# Access Compliance Report

## Public Rights-of-Way

### (Curb Ramps)

Intersection ID: 10865	Main Street: SUMTER_AV	Cross Street: AUTEN_ST	Location: S
ADA ID: 7E59E4A34DD2	Ramp Type: Perp	Initial Pass/Fail: Fail	Overall Compliance: No
		Severity Score: 55

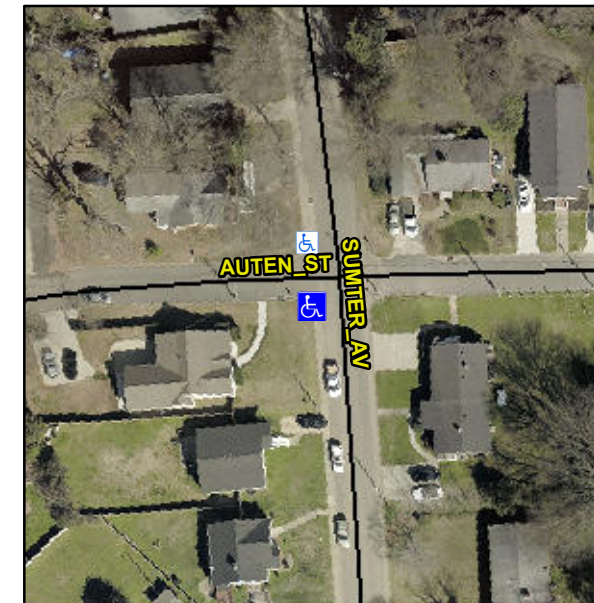
**Not Found, R304.5.1, R304.2.2, R304.5.3**

Compliance	Description	Data	Compliance	Description	Data
N/A	Ramp Length (in)	46.0	No	Ramp Slope (%)	9.4
No	Ramp Width (in)	34.0	No	Ramp XSlope (%)	13.4
N/A	Flare Type LT	N/A	N/A	Flare Type RT	N/A
N/A	Flare Slope LT (%)	N/A	N/A	Flare Slope RT (%)	N/A
N/A	Flare Traversable LT?	N/A	N/A	Flare Traversable RT?	N/A
N/A	Landing Length (in)	N/A	N/A	DWS Provided?	N/A
N/A	Landing Width (in)	N/A	N/A	DWS Contrast?	N/A
N/A	Landing Slope (%)	N/A	N/A	DWS Length (in)	N/A
N/A	Landing X Slope (%)	N/A	N/A	DWS Full Width?	N/A
N/A	Landing Curb? (Y/N)	N/A	N/A	DWS Offset (in)	N/A
N/A	Shared Landing?	N/A			
N/A	Gutter Ponding?	N/A	N/A	Gutter Slope (%)	N/A
N/A	Gutter Lip Ht (in)	N/A	N/A	Gutter X Slope (%)	N/A
N/A	Painted X Walk1?	No	N/A	Painted X Walk2?	N/A
	X Walk 1 Direction	To N		X Walk 2 Direction	N/A
N/A	X Walk 1 Width (in)	N/A	N/A	X Walk 2 Width (in)	N/A
	X Walk 1 Slope (%)	12.7		X Walk 2 Slope (%)	N/A
	X Walk 1 X Slope (%)	2.3		X Walk 2 X Slope (%)	N/A

**Remove & Replace Entire Ramp.**
